FALCON HIGHLANDS SOUTH FILING 1

CONSTRUCTION PLANS

CLIENT
CHALLENGER HOMES
FALCON HIGHLANDS SOUTH – FILING 1
EL PASO COUNTY, COLORADO
CONSTRUCTION PLANS
COVER SHEET

SAHALEE TRAIL

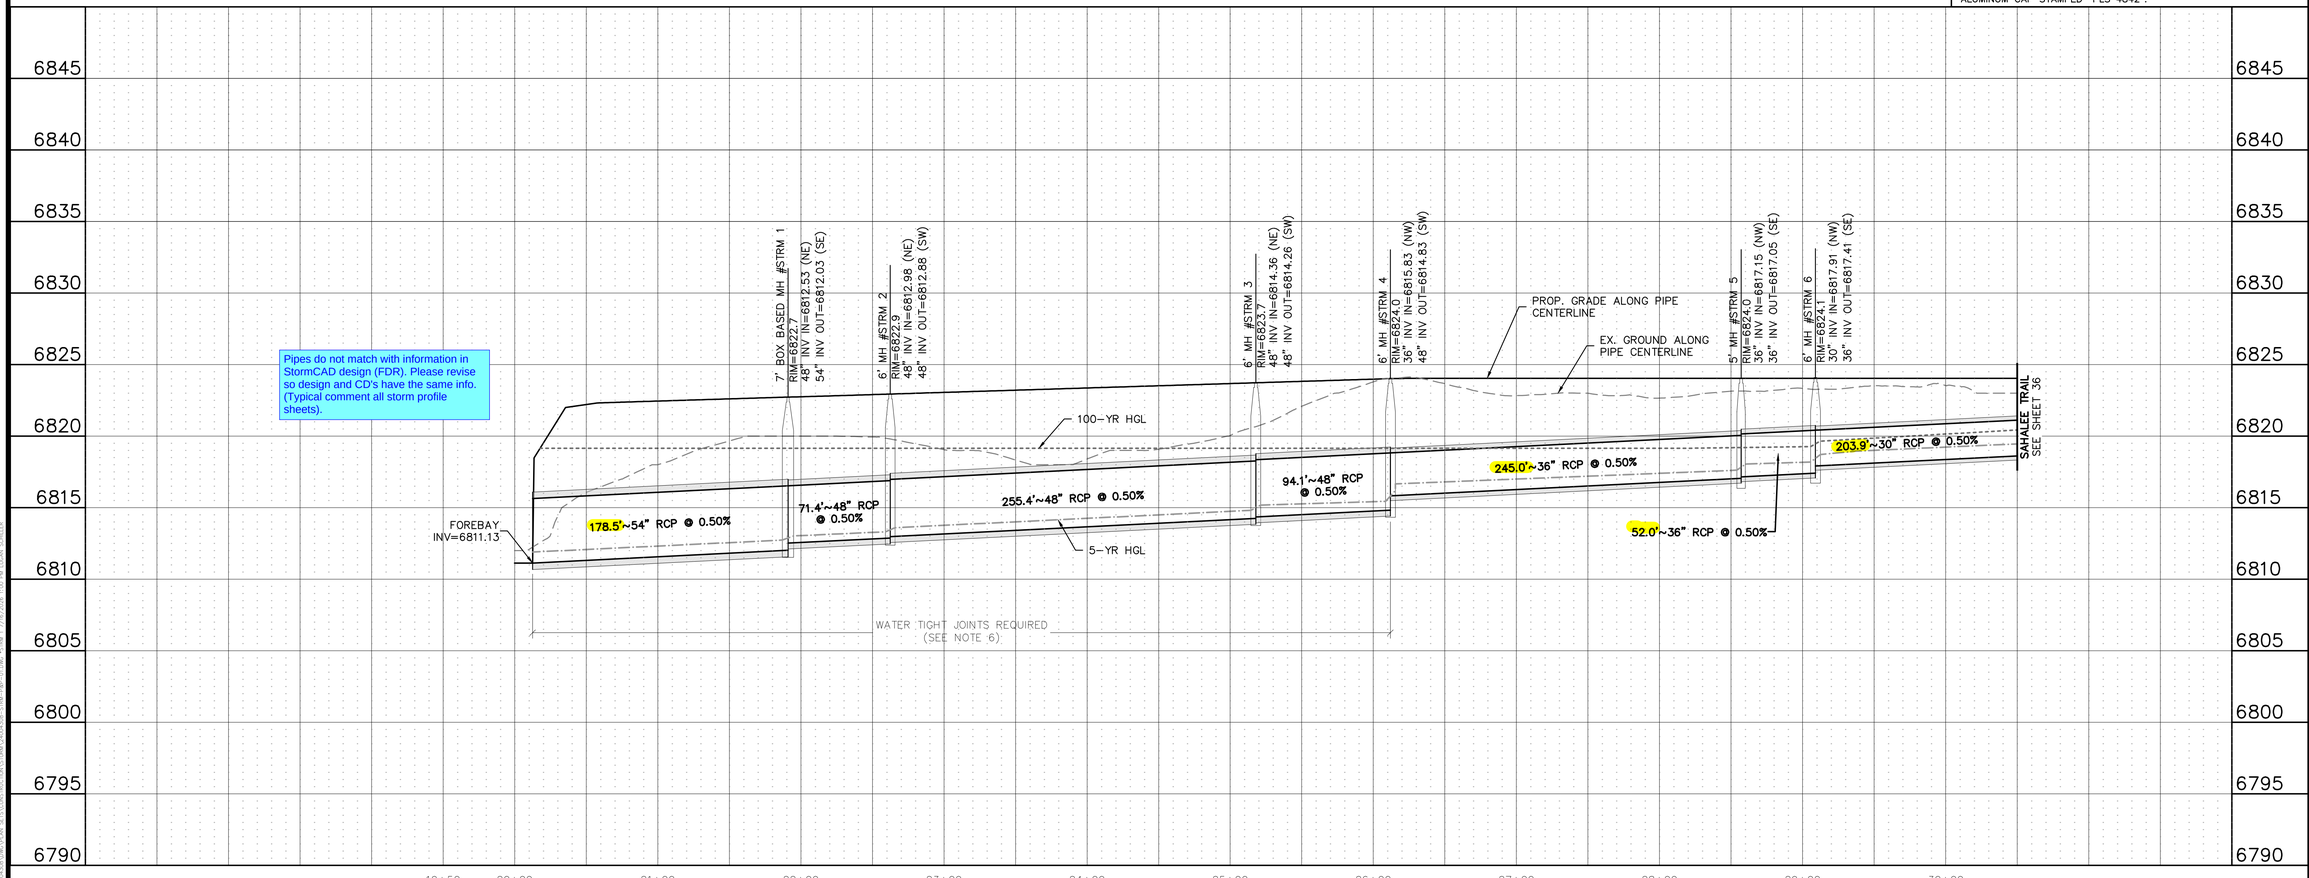
Pipes do not match with information in StormCAD design (FDR). Please revise so design and CD's have the same info. (Typical comment all storm profile sheets).
